Note

To obtain a higher idle speed at low ambient temperatures following a cold start, the vacuum box on ignition distributor (harder spring) and the connection for the ignition retard adjustment (white-yellow line) has been modified. The connection for the ignition retard adjustment is now on contoured hose between supplementary air valve and idle speed air distributor. The connection on throttle valve housing for ignition retard adjustment used up to now has been discarded.

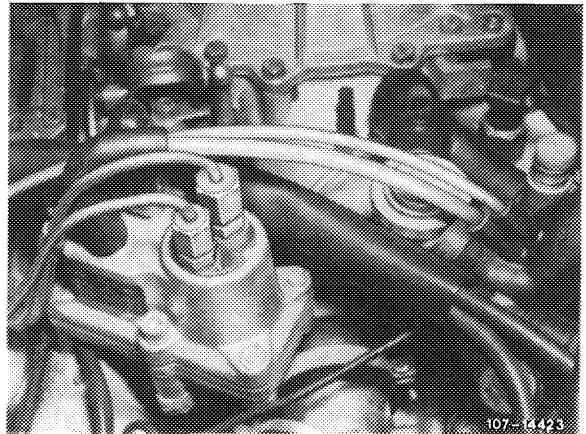
As a result of this change, the ignition is **not** adjusted toward retard at low ambient temperatures following a cold start as a result of the low intake pipe vacuum (supplementary air valve open). The idle speed will be raised by approx. 150–200/min immediately following a start.

- 1 Install modified contour hose.
- 2 Pull vacuum line white/yellow from throttle valve housing and connect to contour hose.
- 3 Close freed connection on throttle valve housing with rubber cap, part no. 000 987 11 45.
- 4 Mount new vacuum control unit for ignition distributor.
